802.3cu D1p0  
proposed editing to 100GBASE-FR1/LR1 and  
400GBASE-FR4/LR4 PMDs.

- This presentation contains 802.3cu D1p0 considerations and proposed relative changes for 100GBASE-FR1/LR1 and 400GBASE-FR4/LR4 PMDs.
- Comments and proposed changes about:
  1. Delta between Average launch power (min), Outer Optical Modulation Amplitude (OMA<sub>outer</sub>) (min)
  2. Allocation for penalties (DGD penalties).
  3. Compatibility between 100GBASE-FR1 and 100GBASE-LR1.
  4. Average power of OFF transmitters.

Table 151–7—400GBASE-FR4 and 400GBASE-LR4 transmit characteristics

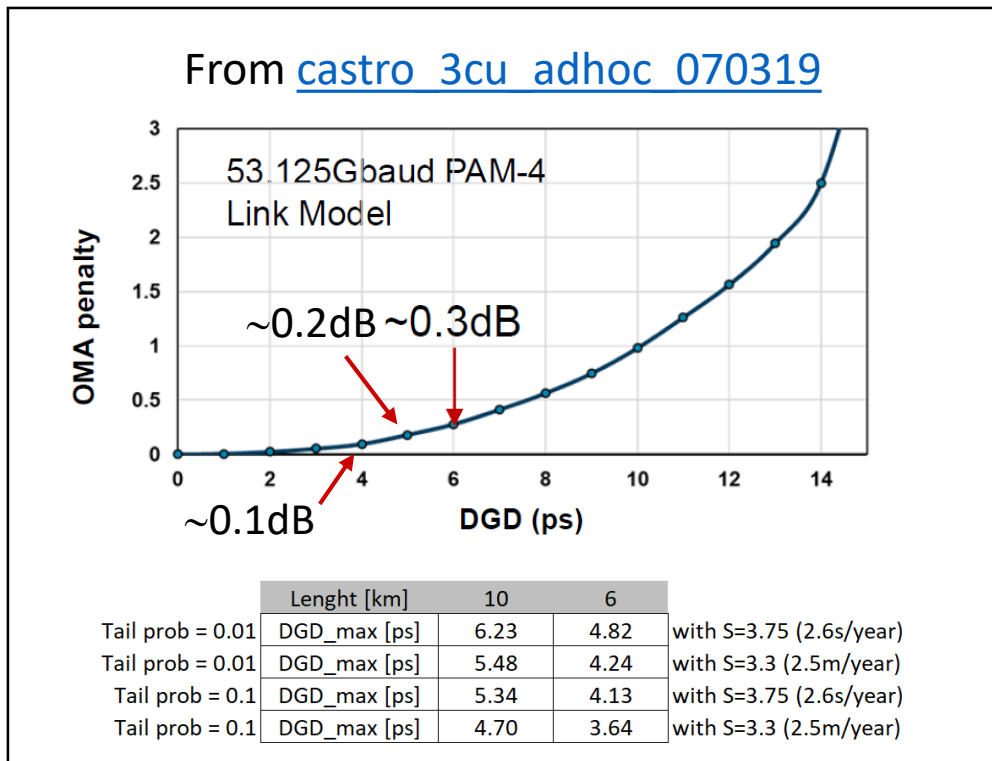
The difference between Average launch power (min) and Outer Optical Modulation Amplitude (OMA<sub>outer</sub>) (min) has been set to 3dB for 400GBASE-FR4 and 400GBASE-LR4 transmitters (equal to the delta considering infinite ER of the transmitter).

This is in line with other adopted PAM-4 PMD in previous standards (e.g. 50G-based PMD (200GBASE-FR4/LR4, 400GBASE-FR8/LR8)).

But this is not applied to 100GBASE-FR1 and 100GBASE-LR1, so in this way we unfairly penalize existing high ER (> 10dB) TXs.

*Note: also 100GBASE-DR too is affected, but is outside the scope of this project.*

*So, to allow interoperability with 100GBASE-DR, 100GBASE-FR1 power should be reduced to its minimum launch power.*

Table 140–7—100GBASE-DR, 100GBASE-FR and 100GBASE-LR receive characteristics

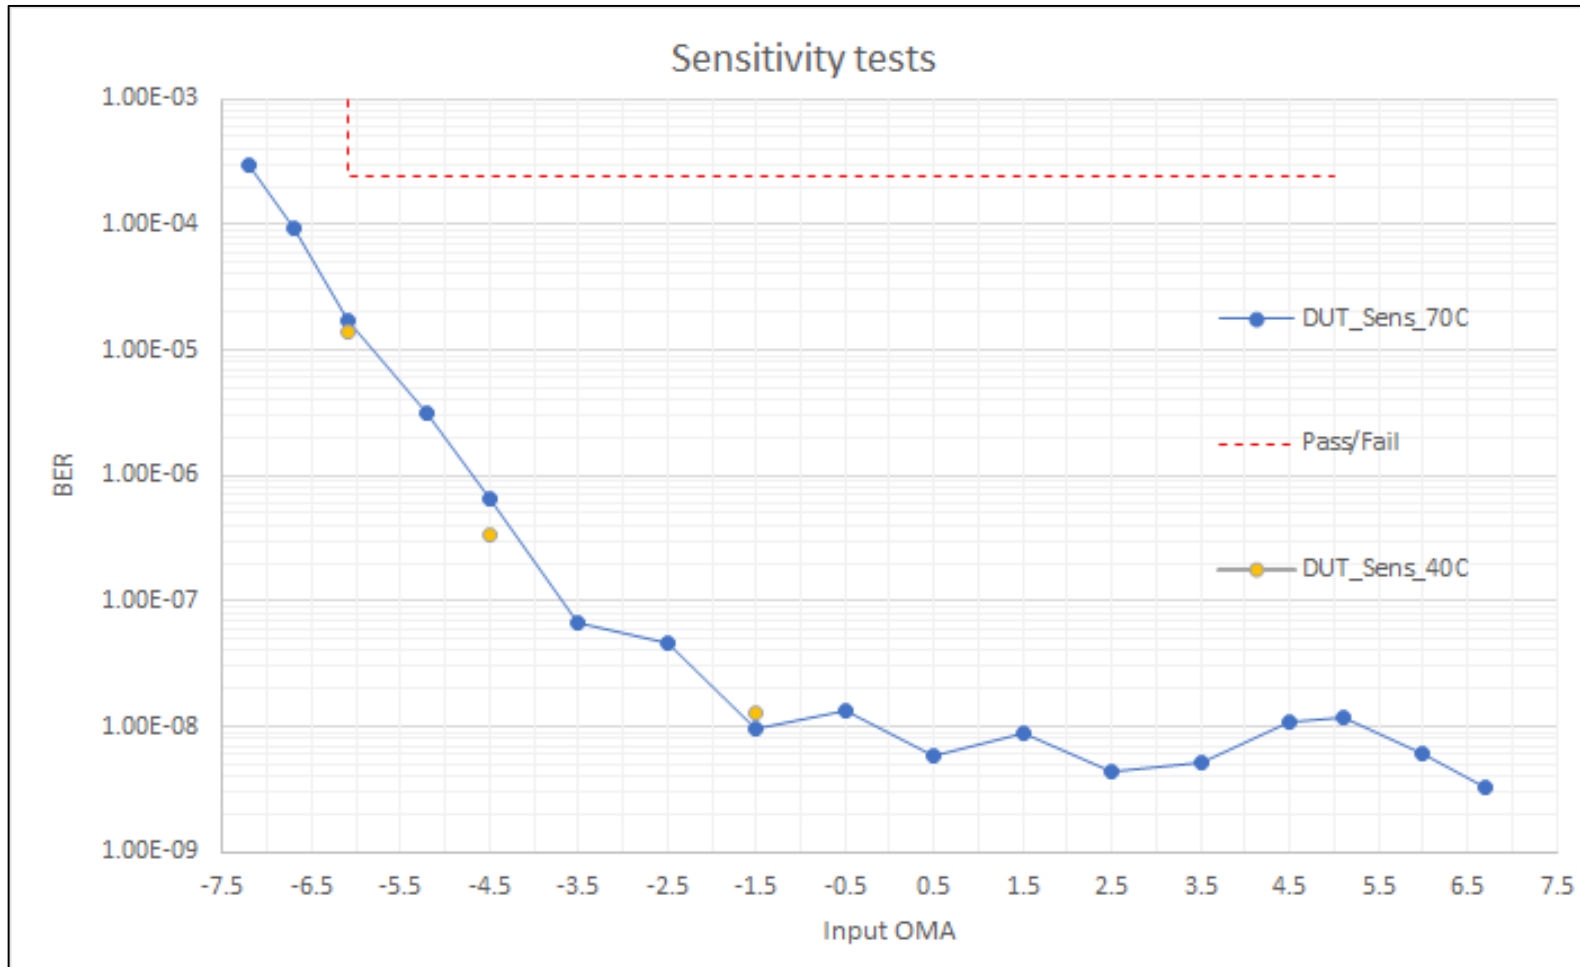
100GBASE-FR1 and 100GBASE-LR1 damage threshold and maximum average received power were kept aligned until draft D0p2, so to ensure compatibility between these two PMDs.

The option to use a 0.3dB attenuator as per Table 140–16 seems not practical because its too small value – minimum attenuator losses should be considered 0.5dB, with an added connection – some costs has to be considered too.

Since 100GBASE-LR1 maximum TX power has been increased into Table 140-6, we now need to align them back again into table 140-7, as well to update 140.10b and related Table 140-16.
